14.1 Volume CIAM General Rules, Section 4A (CIAM Internal Regulations)

14.2 Volume CIAM General Rules, Section 4B

14.3 Volume CIAM General Rules, Section 4C (General Rules for International Events)

14.4 Volume CIAM Records

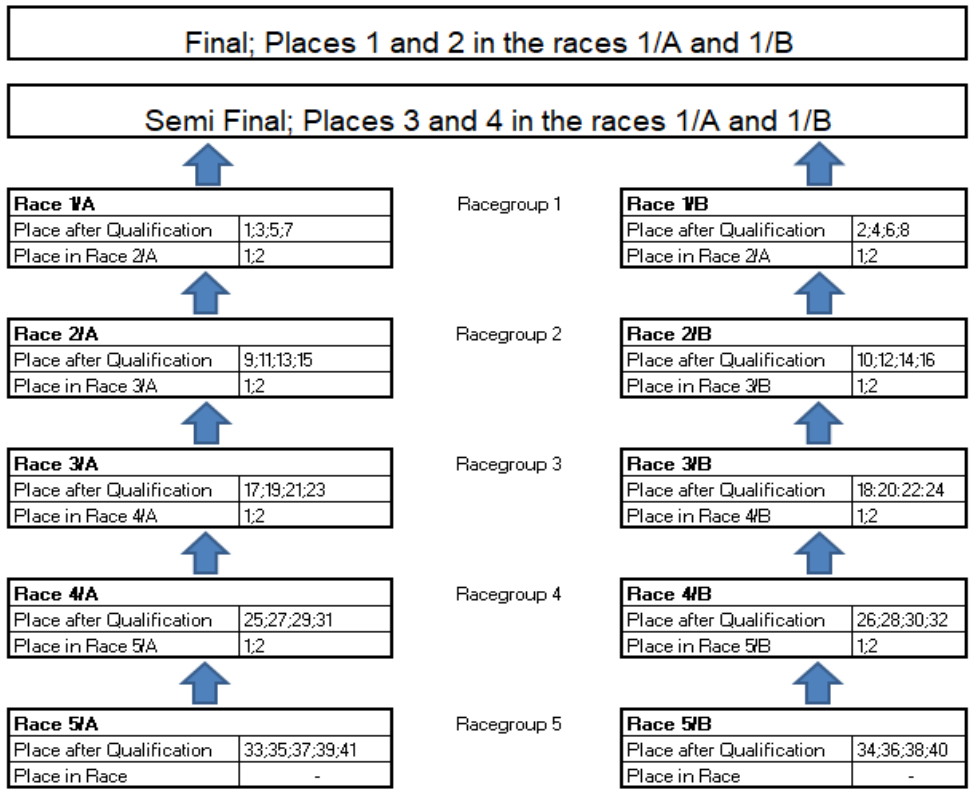
All races with participants who had reached a straight placement forms the race column A.

All race with participants who had an odd placement, forms the race column B.

Two races each from the race columns A and B at the same height form the race group.

From each race of a race group, the two best drivers climb into the race of the next higher race group.
